Aqueous Solutions (owner) AQS-MFG-MET_HX_Q4-IN01
MET_HX_Q4 fabrication drawing IN01 (AQS-PLAN-006 M3; graph r
Type: fabrication drawing (GA / nozzle orientation / part sheet) Rev affabeb1 Issued 2
Created: flow graph pipeline Approved: not approved (study)
Sheet 1 of 1 AQS-DWG-001

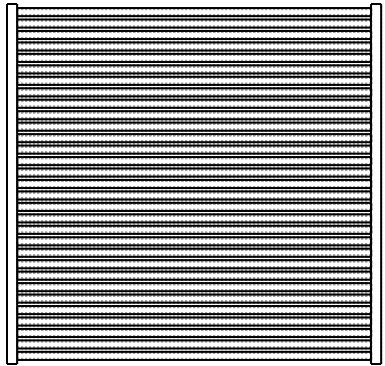
Graph revision AC - in01: Bundle: 198 tubes OD 12 x 525 between two 15 mm tube sheets, 3.9188 m2 DRAWN
Graph revision AC - in01: A-HX: the area is reported as drawn, NOT called calculated - the node carries no heat rate (duty section 2)
Graph revision AC - in01: Tube wall 1.5 mm is a study value (hold, W12); tubes lap both sheets
